Re: Route 66 Plaza

Request for Certificate of Occupancy

30-Day Temporary Certificate of Occupancy- Transportation Development

AS-1.0

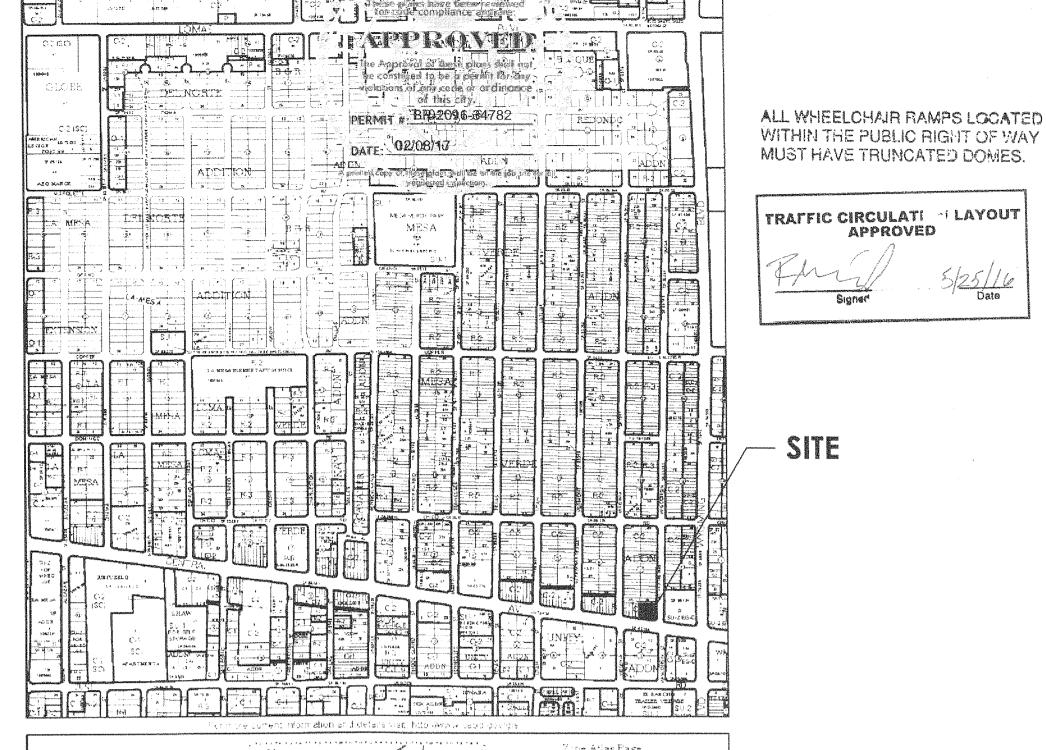
1. Please add bike rack per city standards. (Attached is section 3.11.2 Bicycle Parking)
